**Department of Energy**  
**National Nuclear Security Administration**  
Washington, DC 20585

**Subject: Laboratory Response to DNFSB Letter Regarding Pu-238 Scrap Recovery Line**

**LANL Response to DNFSB Letter  
Regarding Pu-238 Scrap Recovery Line  
June 3, 2001**

Fig. 10. Correspondence between absorbed gamma dose and years of normal operations at TA-55.

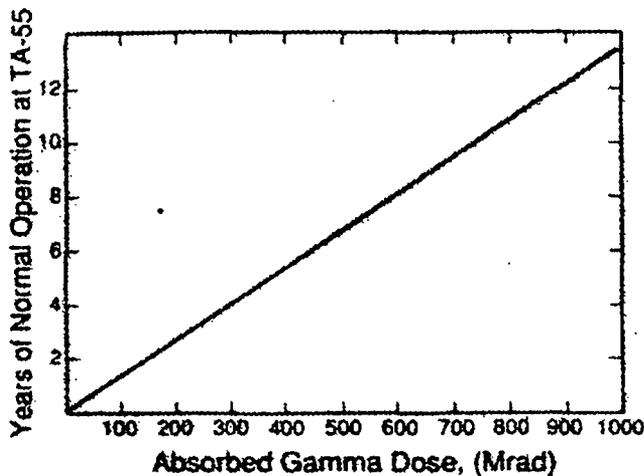
With regard to the DNFSB Staff Issue Report<sup>2</sup> concern relative to the resin dryout issue during a facility power failure and subsequent building evacuation, the DOE approval memo<sup>5</sup> referenced a report entitled *The Effects of Ionizing Radiation on Reillex™ HPQ, a New Macroporous polyvinylpyridine resin, and on Four Conventional Polystyrene Anion Exchange Resins*, LA-11912, November 1990, by S. Frederic Marsh.<sup>15</sup> To assist in clarifying this issue, an excerpt from the report is reproduced here.

As shown in Fig. 10, an absorbed dose of 370 megarads corresponds to about 5 years of normal plutonium-processing operations at the Los Alamos Plutonium Facility (TA-55), which would indicate that the threshold for the observed thermal instability of Reillex™ HPQ resin could occur only after 5 years of routine operation at TA-55. (The Los Alamos Plutonium Facility, which operates a single shift five days per week and stores ion exchange columns in 1 M nitric acid between shifts, should not be used to estimate resin lifetime elsewhere.) Because resin damage from alpha particles is lower by at least a factor of two (see the following Alpha-Particle Irradiations section), however, the threshold for the cited thermal instability of Reillex™ HPQ resin actually corresponds to more than ten years of normal operations in the Los Alamos Plutonium Facility.

The combination of two factors—the improbability of resin becoming dried and heated during production operations and the required induction period of greater than 10 years at Los Alamos—virtually eliminates any possibility that thermal instability could occur in a production environment. Nevertheless, we recommend that Reillex™ HPQ resin be replaced after not more than 5 years of service, or 700 megarads of alpha-particle irradiation, or 400 megarads of absorbed gamma dose.
